STAFF REPORT
KETCHUM PLANNING AND ZONING COMMISSION
MEETING OF SEPTEMBER 15, 2020

PROJECT: 4th & Walnut Ave Commercial Development Design Review

FILE NUMBER: P20-046

APPLICATION TYPE: Design Review

DETAIL SHEET
4TH AND WALNUT
 LOCATED WITHIN SECTION 18, T.4 N., R.18 E., B.M., CITY OF KETCHUM, BLAINE COUNTY, IDAHO
 PREPARED FOR WALNUT & FOURTH LLC
 PROJECT INFORMATION
 P:\addshore\78191\eng\Construction\1819-ENG-BASE.dwg 000620 10:14:52 AM

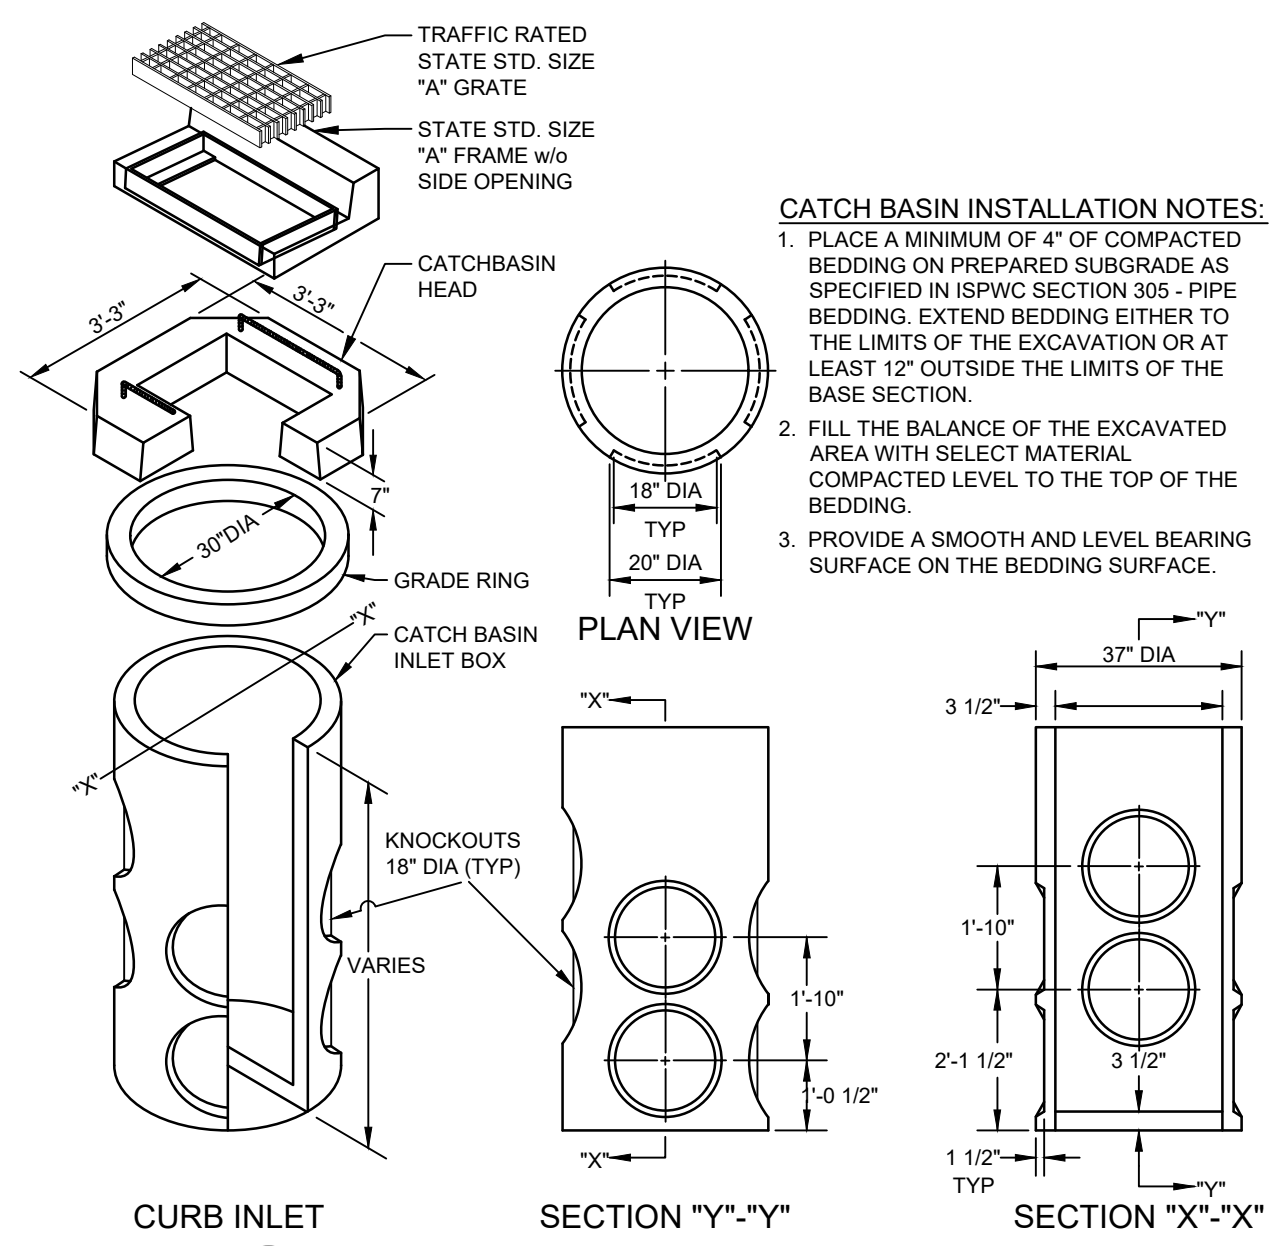
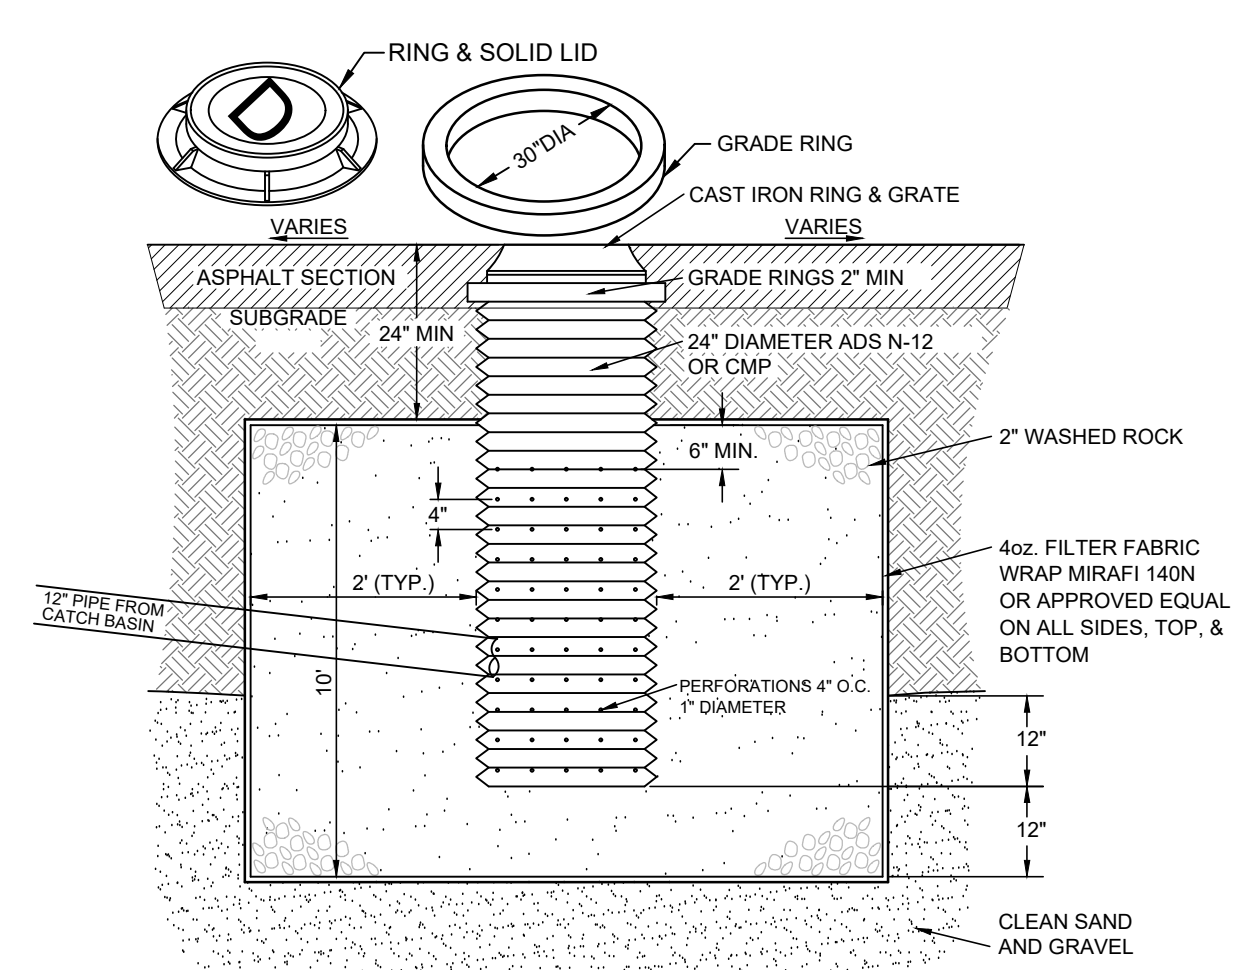
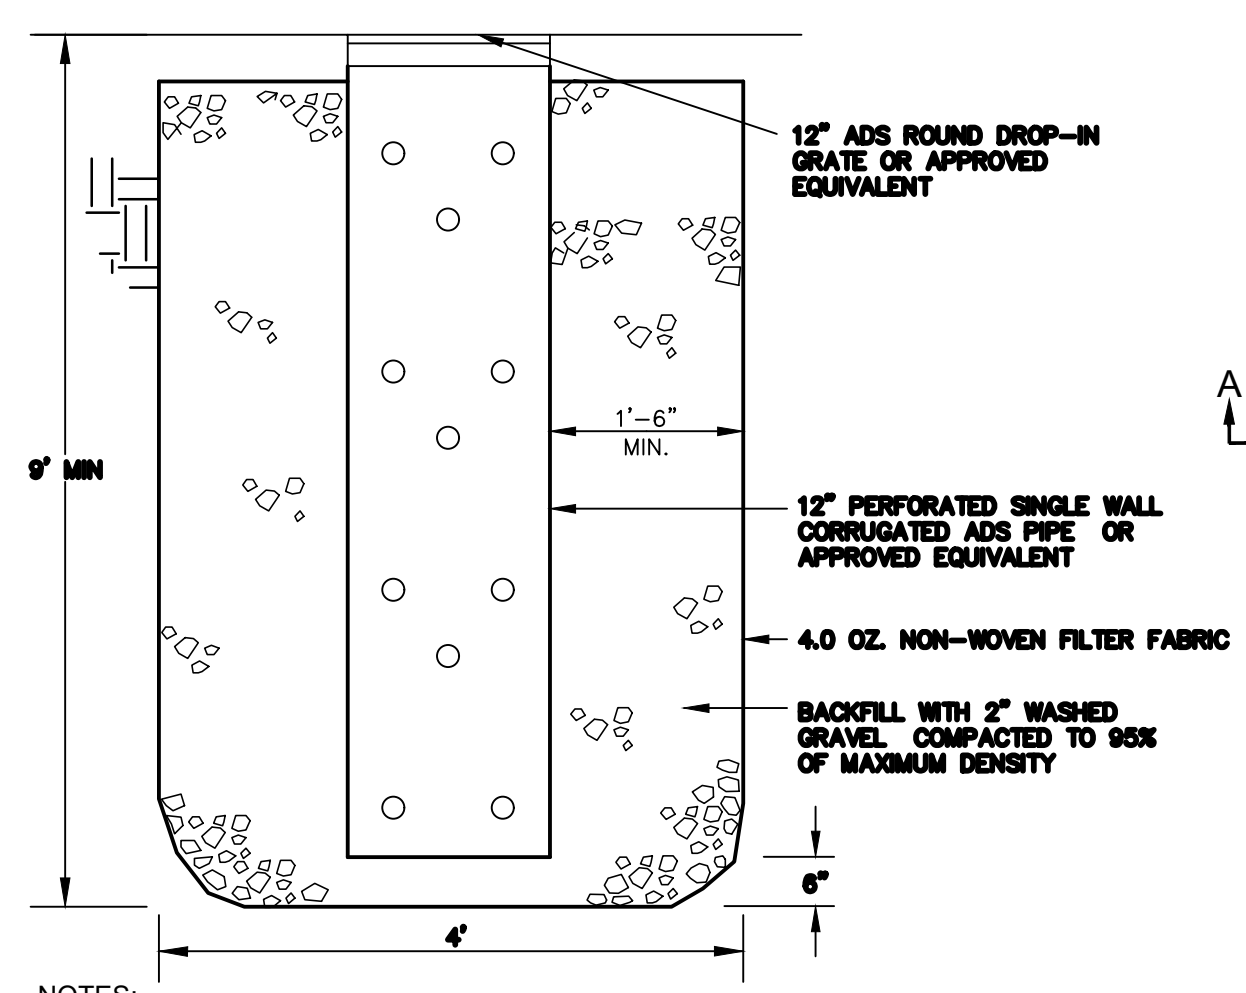
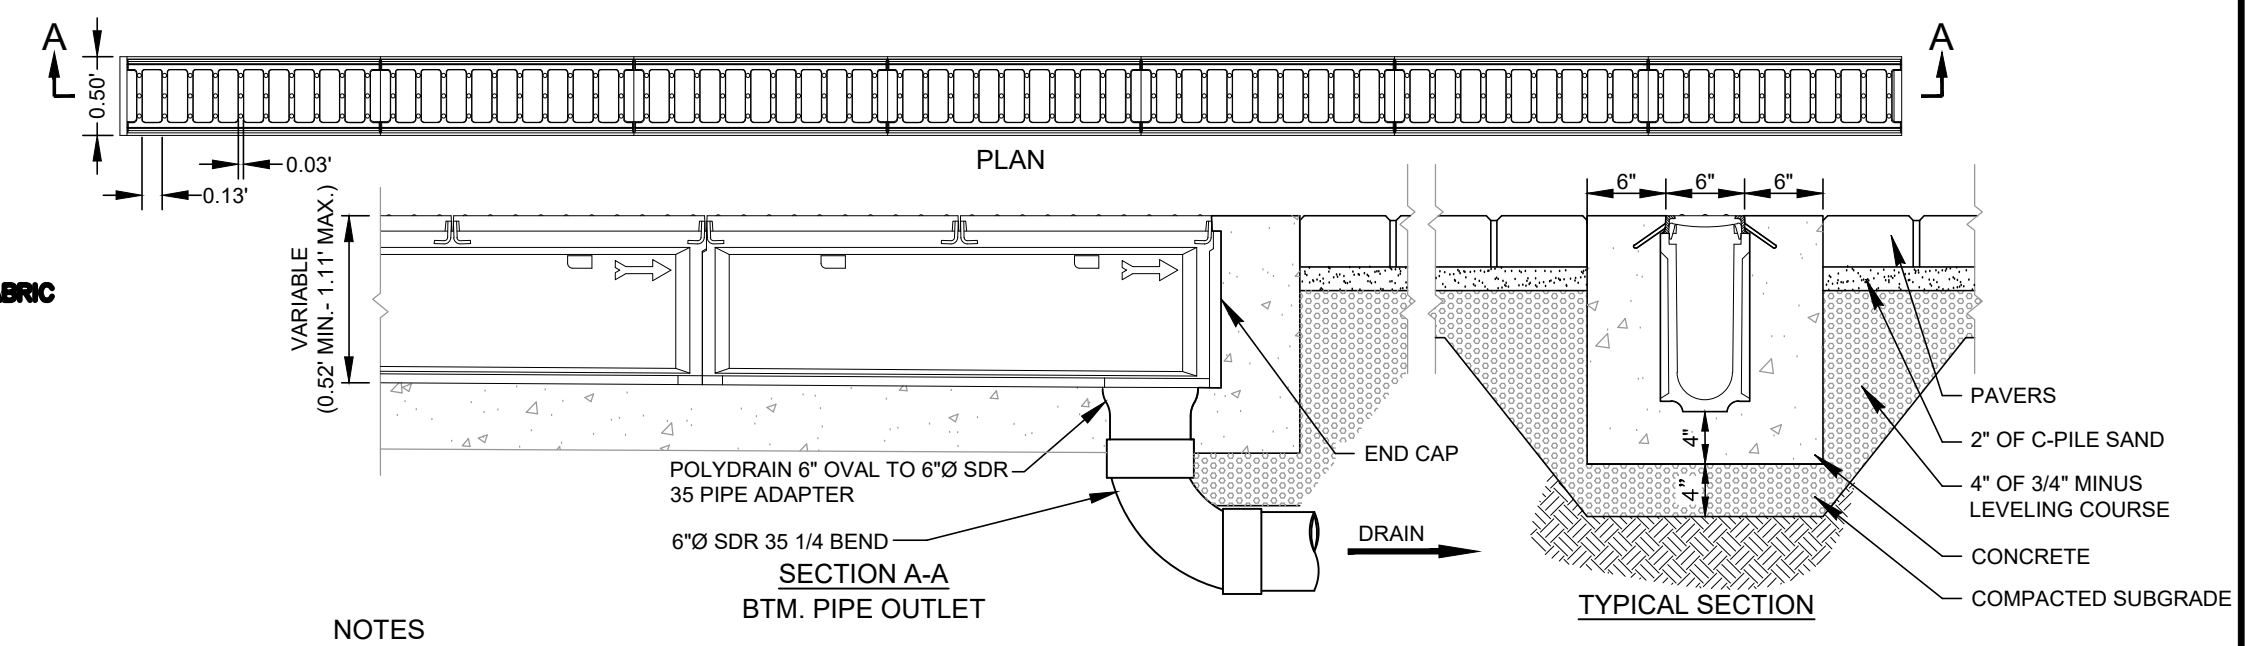
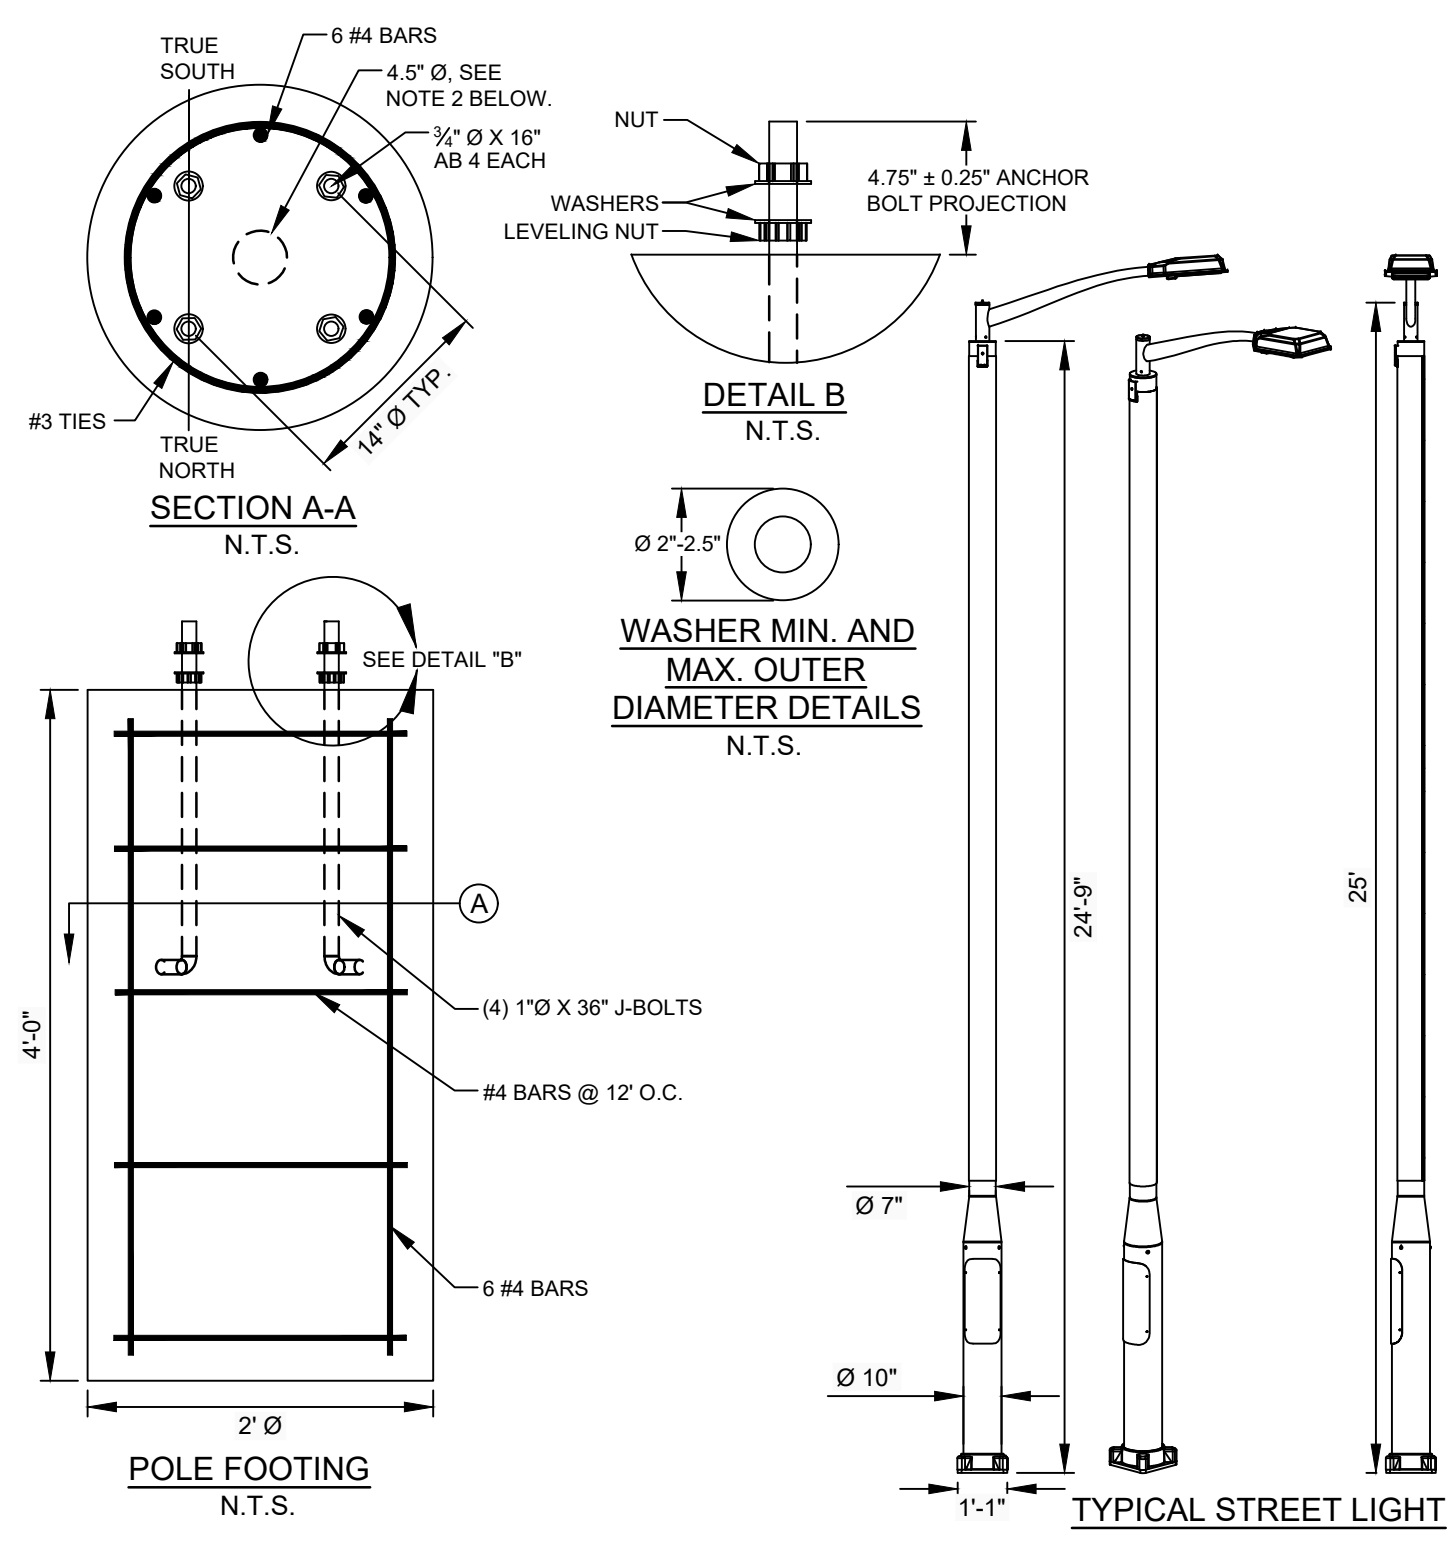
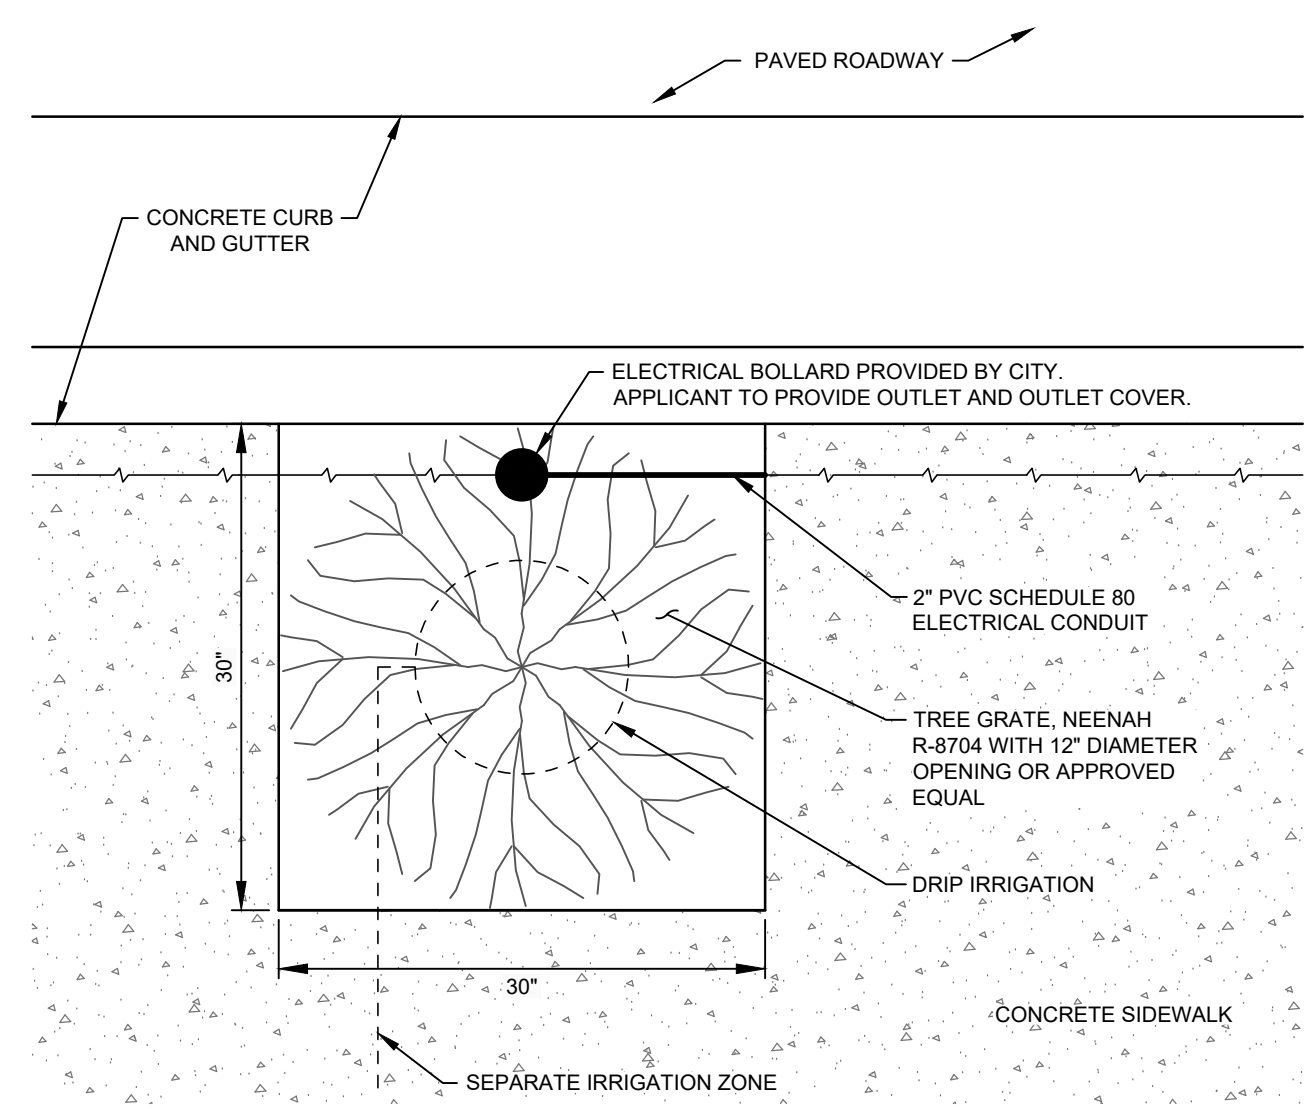
| | | | Staff Comments | <i>The tree well details are indicated on Sheet C0.2 of the project plans. The 4 street trees are proposed to be installed in tree wells and covered by grates.</i> <i>The applicant has proposed four street trees within the ROW along Walnut Avenue and 4th Street. Street trees may be considered if a snowmelt system is installed for the sidewalks. Streetscape improvements must be indicated on civil plans submitted with the building permit application for final review and approval by the City Engineer and Streets Department. If approved by the City Engineer and Streets Department, all encroachments within the ROW require an Encroachment Permit.</i> |
